Invitation for Comment on Wooing Tree Estate

The Wooing Tree Estate is a Referred Project under the COVID-19 Recovery (Fast-track Consenting) Act 2020

Application name	Wooing Tree Estate
EPA reference	FTC000029
Applicant/s	Wooing Tree Property Development LP
Comments due by	Wednesday 30 June 2021
Accessing the application	The full application and supporting documents can be viewed on the EPA website, which can be accessed here: https://www.epa.govt.nz/fast-track-consenting/referred-projects/wooing-tree-estate/

Comment on the Wooing Tree Estate project

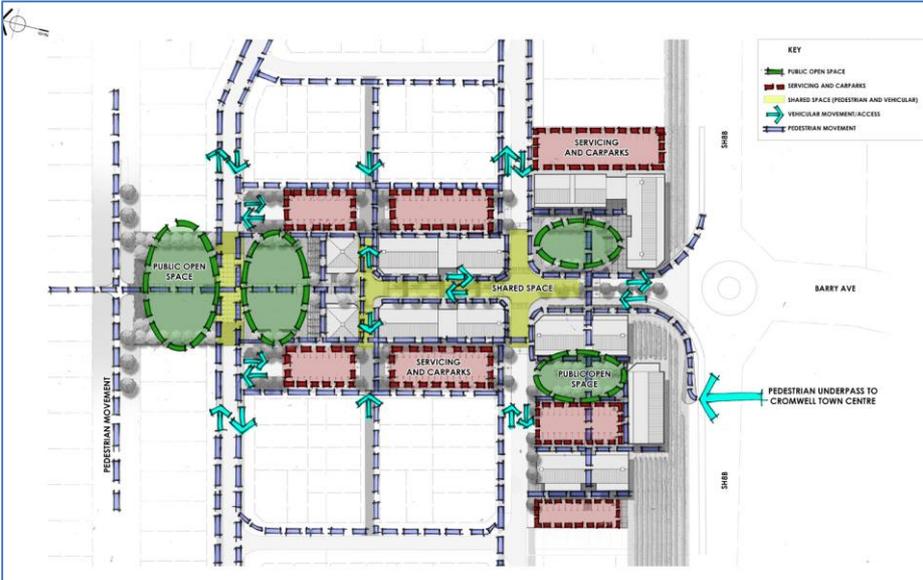
These rules are included in a similar form within the District Plan across all the Wooing Tree Overlay zones. The trigger point meant approximately between 70-100 lots would use Shortcut Road prior to the roundabout and main access from SH8B being constructed.

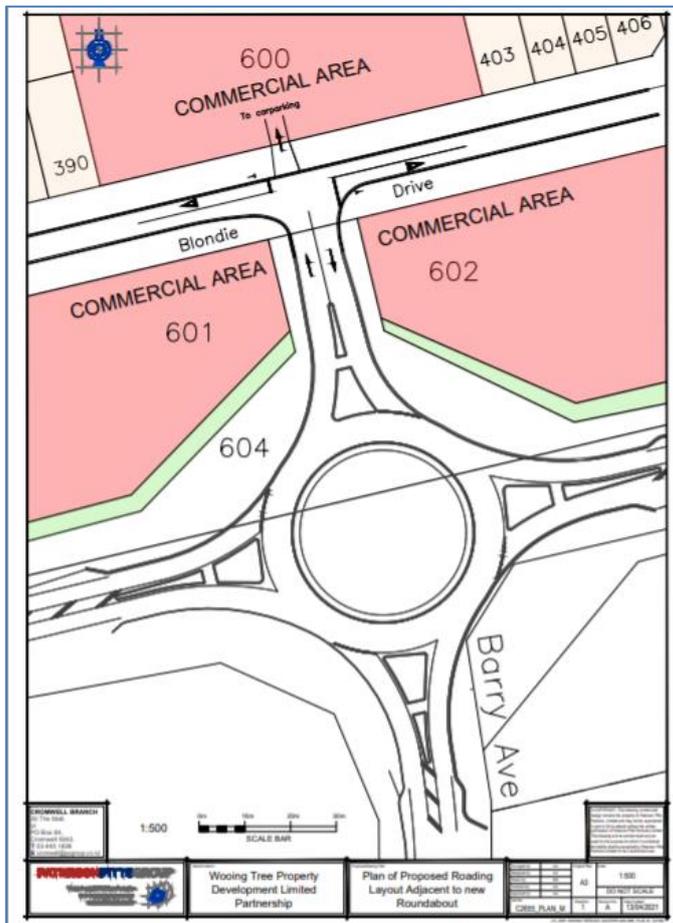
The application as lodged appears to include a number of potential roading layouts for how the internal intersection between Blondie Drive and the commercial area (Lot 600) will work. Diagram 6 of the application, which is also the Commercial Precinct Connectivity Plan in the Urban Design Report at Attachment B, shows the commercial shared area including this intersection as having two-way traffic on all limbs as below.

This layout is different from the Barry Ave Intersection Plan in Attachment O of the application, which indicates traffic will be restricted to one-way entry into the commercial shared area. As a result, we have assumed the more up to date plan “the one-way version” as below is the layout the applicant is proposing.

There are also no clear plans of how pedestrians and cyclists will move from the underpass to the commercial area and how they will safely cross Blondie Ave at this intersection. This is discussed in more detail below.

The location of this intersection close to the roundabout and how it is proposed to work is of concern to Waka Kotahi. These concerns are covered in more detail below. However, we would note the application as lodged does not provide enough information and the information provided is contradictory on how this crucial intersection will operate.

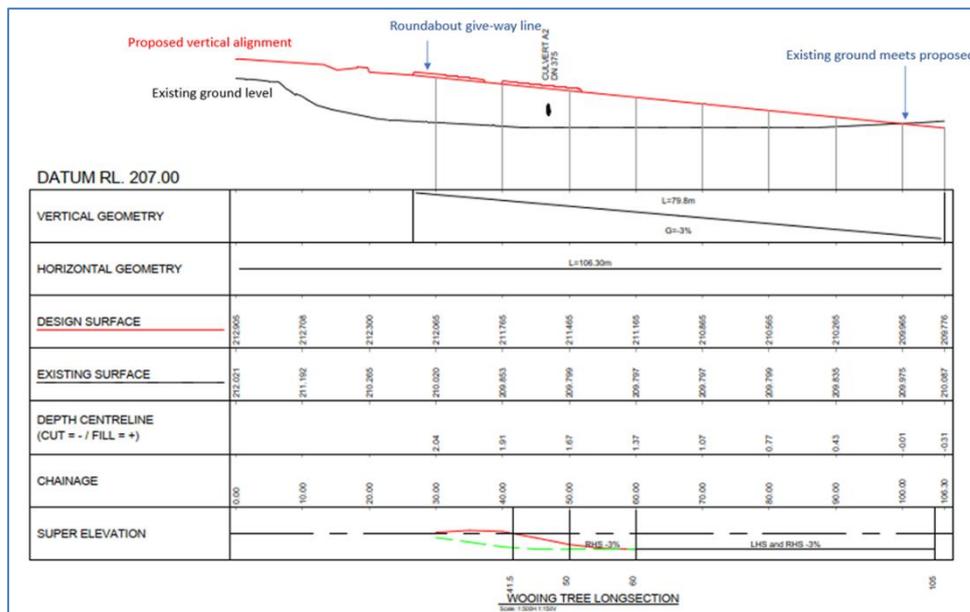
- a. Priority: The priority of the traffic coming from the roundabout is important as the main access into the site. Therefore, the first link from the roundabout to the internal intersection will carry the majority of traffic (compared to all the other arms at the first internal intersection), and it should be classified as the major link and be the main priority at this first intersection to avoid any queuing back into the roundabout. This priority should continue onto the link towards Shortcut Road, so that
 - i) this is indicated as a desirable connector link as already signalled in the district plan, and

- ii) to remove any traffic on the inbound link (from the roundabout to the first internal intersection) requiring to give-way to other traffic at the intersection (i.e. to prevent traffic queues back towards the roundabout). Although attachment G of the application (Transportation Assessment) has assessed the queues on this approach to the first intersection are minimal (95th percentile queue of 2 vehicles) should the link give-way to Blondie Drive, on occasion queues will be greater and may consist of four coaches and other larger vehicles – this reduces the Sight Stopping Distance (SSD) to below the required distance to enable a normally alert driver, travelling at the design speed on wet pavement to perceive and brake to a stop before reaching a hazard, which is around 40 m for a 40kph speed. Therefore, the short inbound link between the roundabout and the first internal intersection at around a length of 45m, introduces a critical road safety concern in terms of drivers exiting from the roundabout having insufficient notice of any downstream queues on this link.

- b. Although the configuration as shown in Attachment O of the application provides an amended priority arrangement that gives priority to the inbound link, the intersection is shown as having a sharp 90-degree bend which is not desirable from both a safety and operational sense. It is therefore difficult to see how priority can be achieved in a safe way without a significant change to the internal road structure and/or alignment.

- x. *The intersection with Blondie Drive and the SH8B/Barry Avenue roundabout shall be designed to provide priority to vehicles travelling from the roundabout towards Shortcut Road.*
- xx. *Prior to the commencement of construction works described in Condition x, the consent holder must provide detailed designs of the Blondie Drive intersection to the Central Otago District Council Manager Transportation Asset Manager for technical review and certification.*
- xxx. *As part of the information submitted in Condition xx, correspondence from the NZ Transport Agency shall be provided confirming that the proposed works meet with the agreement of the NZ Transport Agency.*
